**REFERENCE: APPLICATION FOR CATEGORY 1, CLASS "A" LICENCE
CAPITAL PAVING INC., MONTROSE PIT
PARTS OF LOTS 71, 74 & 75 CONCESSION G.C.T
TOWNSHIP OF WOOLWICH, REGION OF WATERLOO**

**RE: Technical Response
Ministry of Natural Resources comment letter dated Oct. 15, 2008
Proposed Capital Paving Inc. Montrose Pit.**

**Reference: Capital Paving Inc., Montrose Pit
Part of Lots 71, 74 & 75, Concession G.C.T.
Township of Woolwich, Region of Waterloo
MNR Response Letter (October 15, 2008)
Stantec Consulting Ltd. Technical Response**

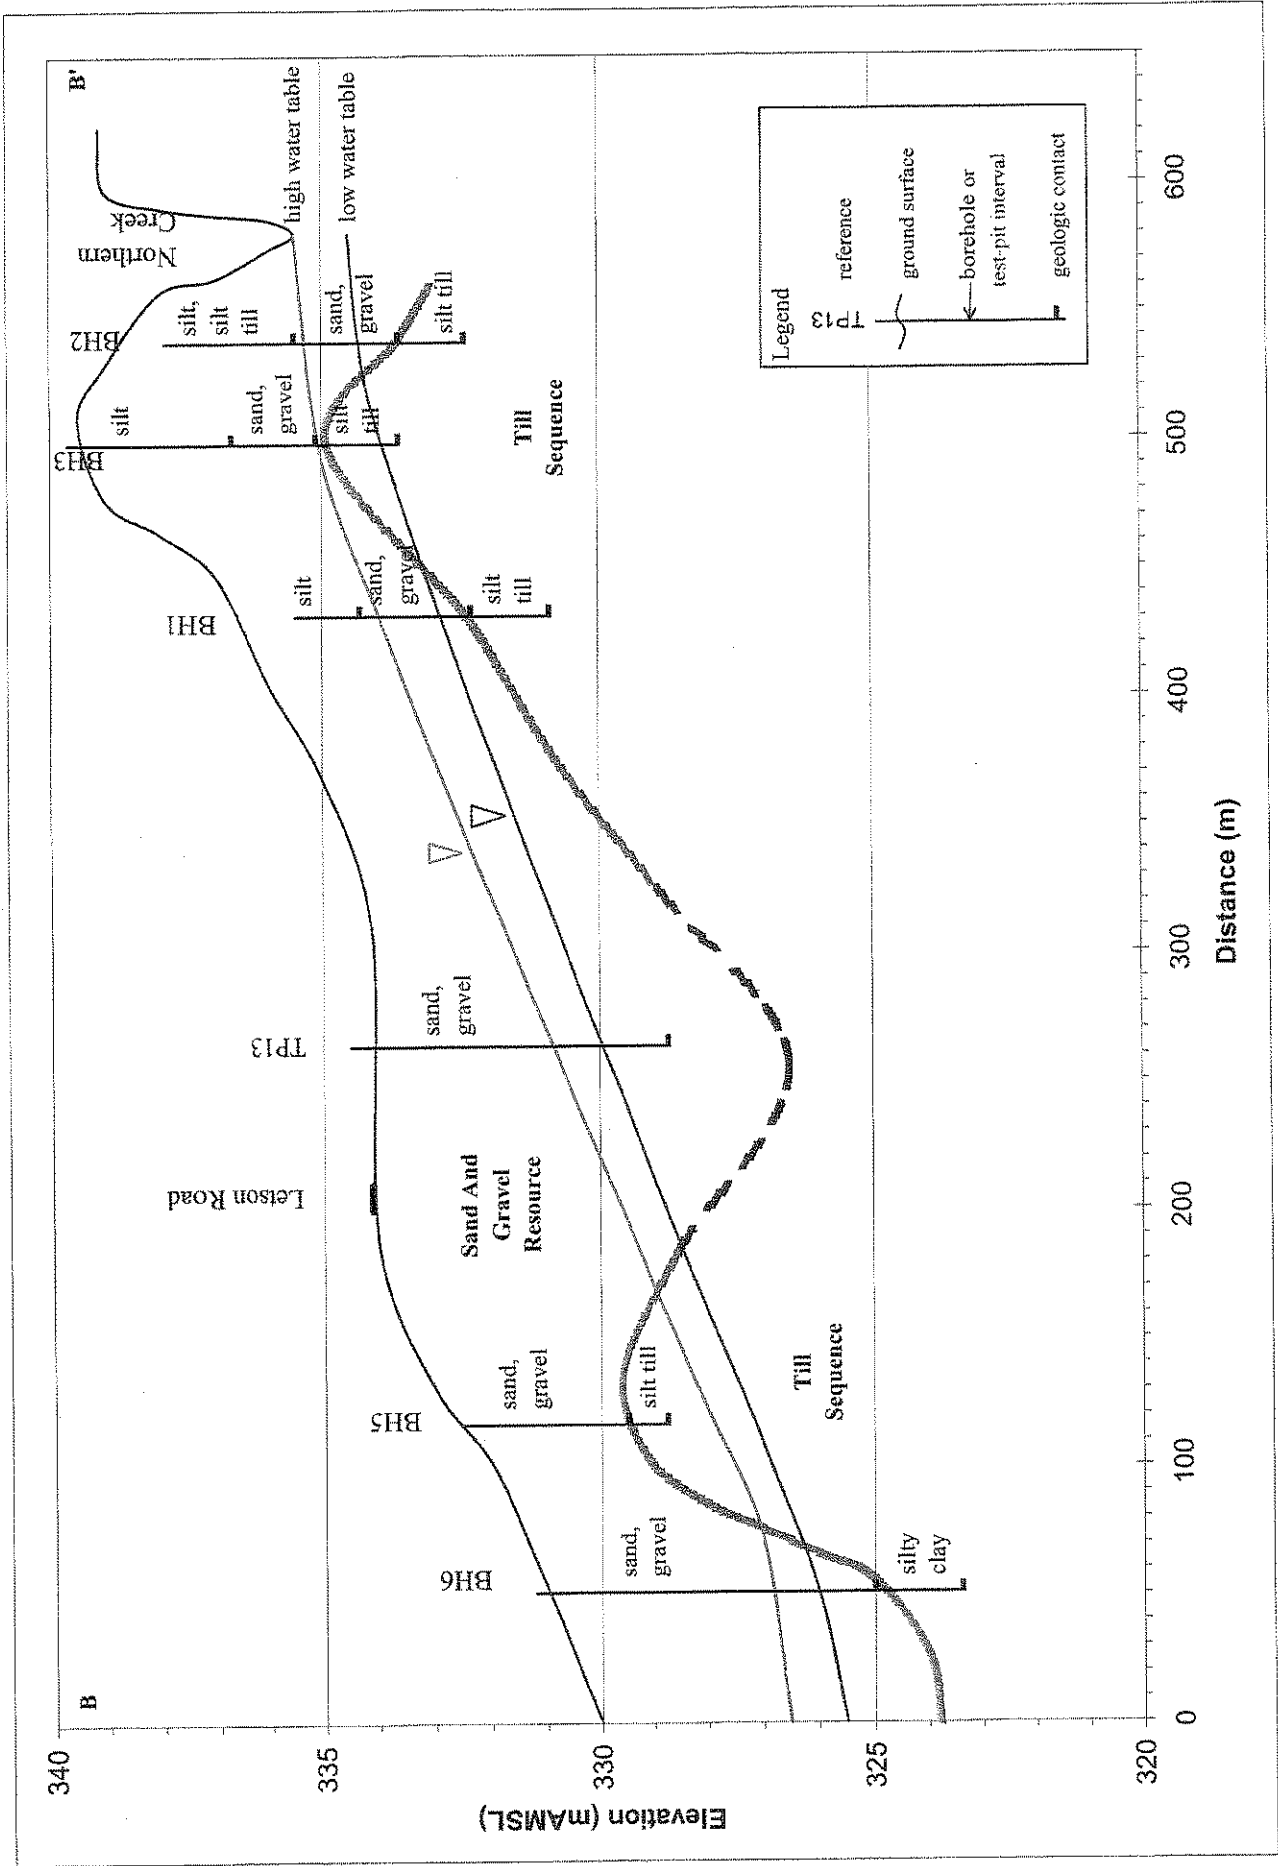
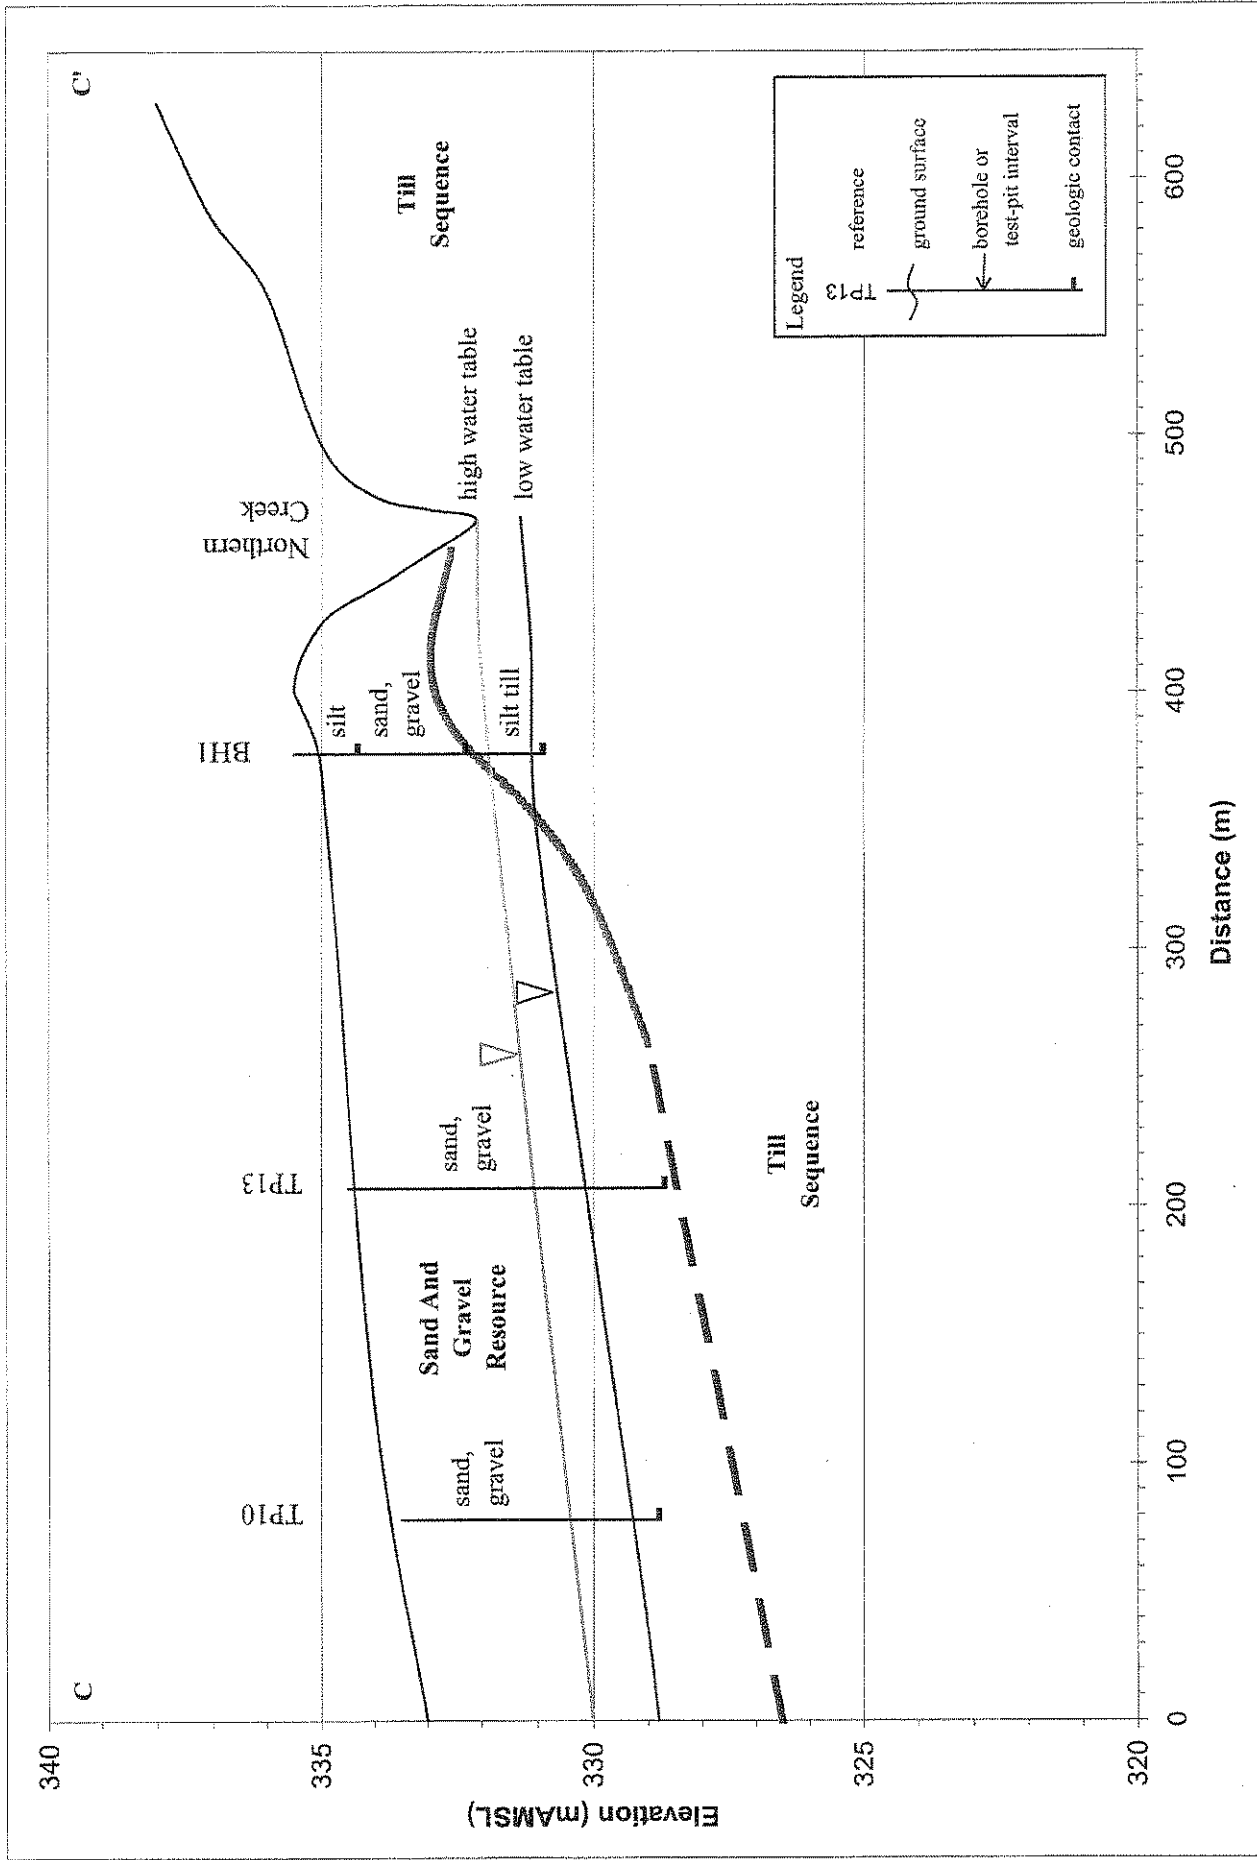
Clarification of groundwater-surface water interaction along northern creek.

The cross-sections show the relative positions of the till unit and high and low water table elevations with respect to the extraction area and the creek channel between DP1 and DP2. Note that the till sequence includes both the Port Stanley (sandy to silty) Till near the surface and the Maryhill (clay) till at depth. Near the creek the till surface rises up to, or above, the creek channel bottom. The creek channel at DP2, and downstream to the north, is developed within the till unit. The till unit effectively captures local recharge and directs local flow along the channel and limits the amount of water that moves from the creek to the sand and gravel unit on-site.

Within this reach of the creek the water table at the creek (and to the south) is constantly lower than the creek level (i.e. the creek is a losing stream). In fact, during the summer when the water table is well below the channel bottom this reach of the creek dries out and most of the stream channel is used as pasture. During these conditions the till unit limits the hydraulic connection between the flow system along the creek and the sand and gravel unit. In the spring streamflow within this reach of the creek is a combination of snowmelt, rainfall and agricultural tile discharge (east of the site). During these conditions the creek channel acts to enhance local recharge, feeding some water "over" the till ridge and into the sand and gravel unit. This can also be seen on the Spring 2008 water table map, as the area along the creek identified as having less than 1 m of saturated sand and gravel.

REVISION EXTRACTION LIMITS

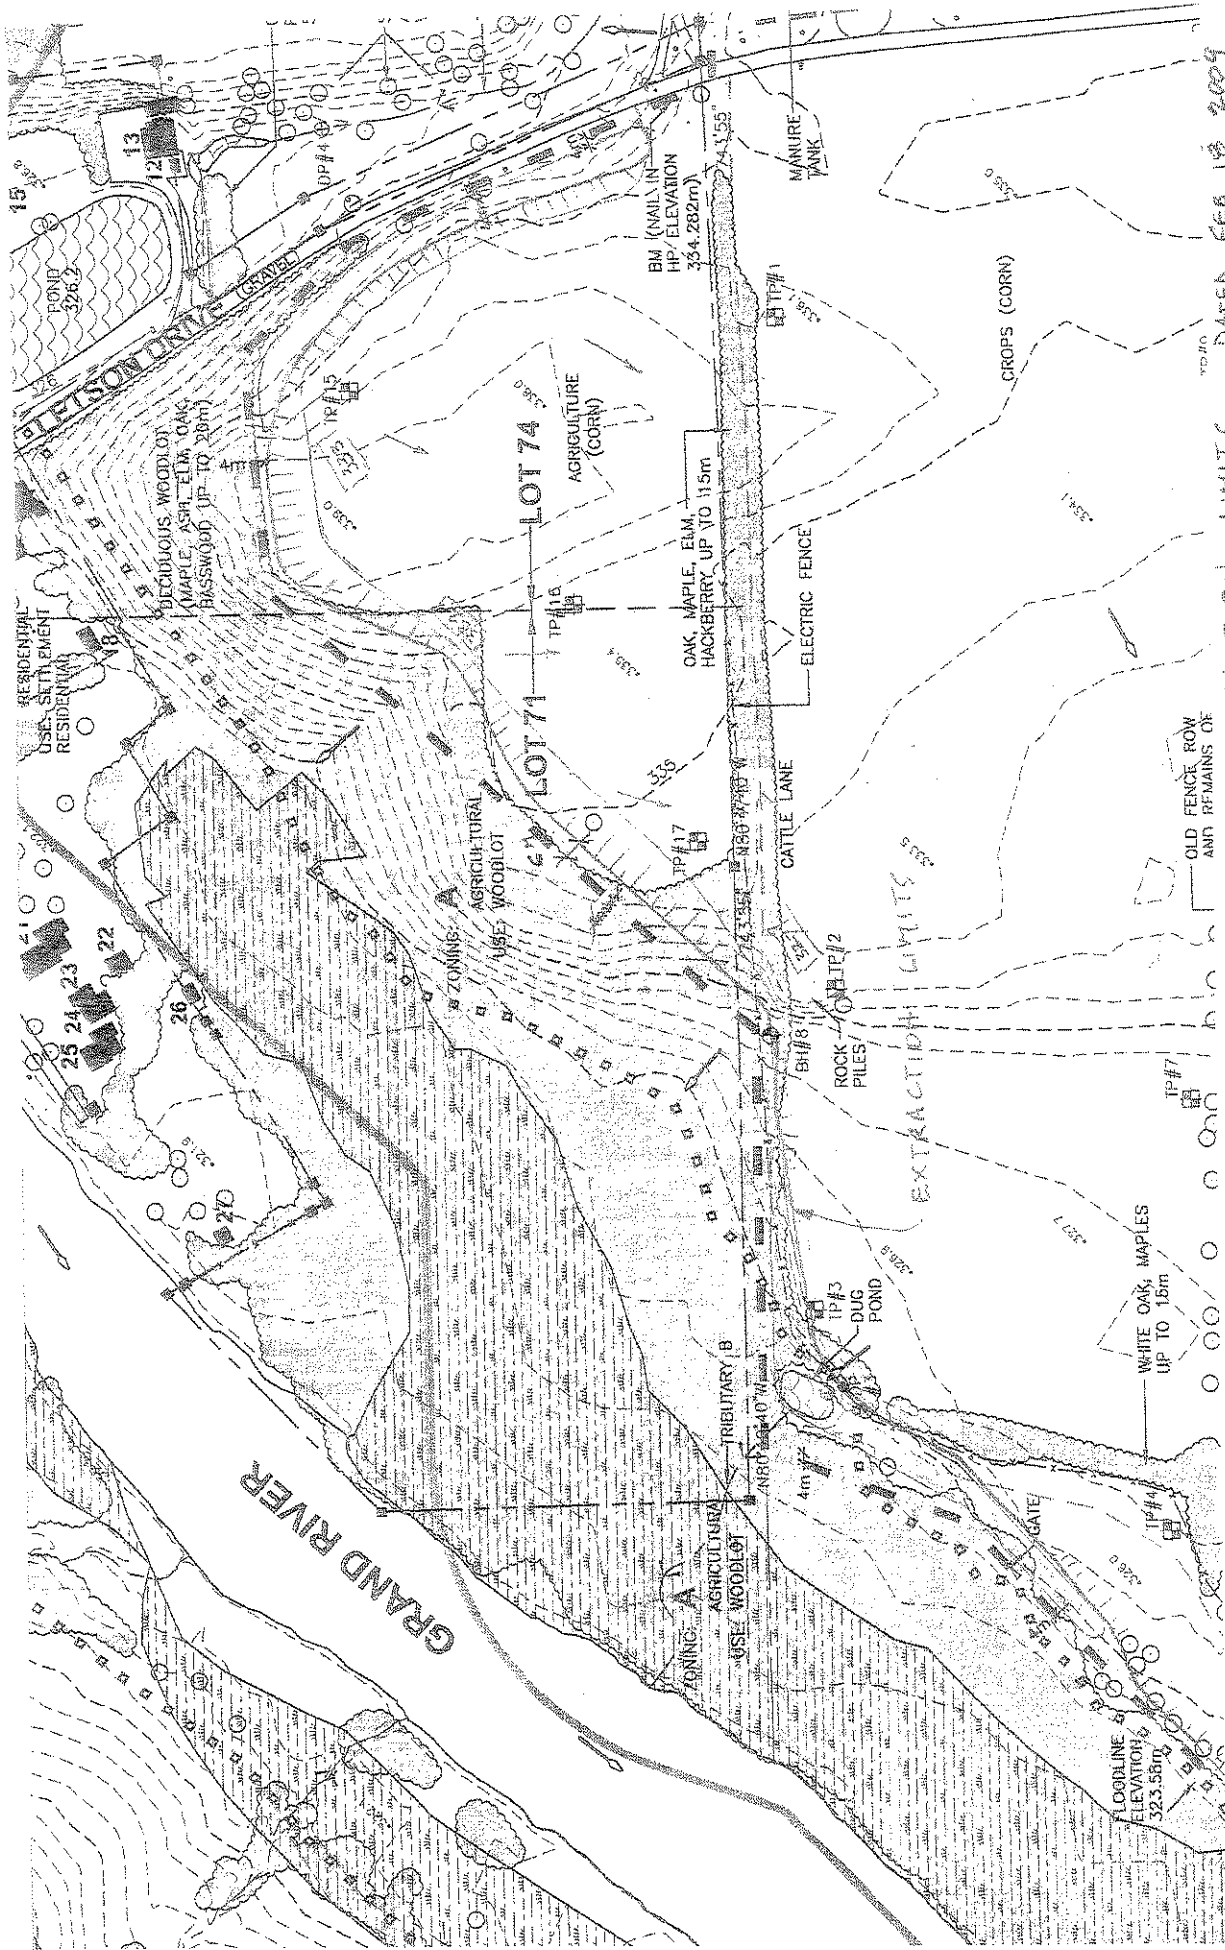
In the project description provided in section 6.0, it is indicated that two 'protrusions' of the woodland on the west side of the site occur within the proposed extraction area. Ministry staff notes that these two areas appear very small relative to the overall extraction area and would appreciate further comments from the consultant on the rationale for their inclusion in the extraction area. Similarly, staff would like clarification on the proposed filling of the cattle pond in the northwest of the property, recognizing that this feature is not within the extraction area and that the pond provides some habitat for amphibians and adds diversity to the nearby wetland area.

As noted the greater majority of the woodland in the area of the proposed site will remain intact. Two small protrusions <0.5 ha are being considered for extraction, however the intent is to replant an area greater than the area covered by the two small woodland protrusions. The reasoning for adopting this management option at this location encompasses a number of considerations, as discussed below.

Capital Paving requested that Stantec review the magnitude of potential impacts associated with proposed removal of the noted two woodland protrusions (<0.5 ha) and provide potential mitigation that could minimize any long term impacts. Capital understands that two woodland protrusion are part of a more extensive forest system and also that the Region of Waterloo and MNR are interested in the long term maintenance of forest cover in the Municipality, Township and watershed. The interest in the protrusions was directly related to the available aggregate at these locations and the desire to provide a more linear agricultural edge for the landowner to facilitate farming.

In consideration of the characteristics of the two areas and habitat provided, Stantec supports the removal of the protrusions with the condition that replanting be completed along the entire post rehabilitation slope with tree plantings that will provide more overall forest cover than the existing area covered by the two protrusions. The new wooded area provides a valuable warm, south facing slope habitat for wildlife. South facing slopes tend to grow rapidly and can provide good habitat for specialized activities such as denning or snake hibernacula. The extent of the added replanting zone is illustrated on Figure 7.0 of the Level II Natural Environment Technical Report.
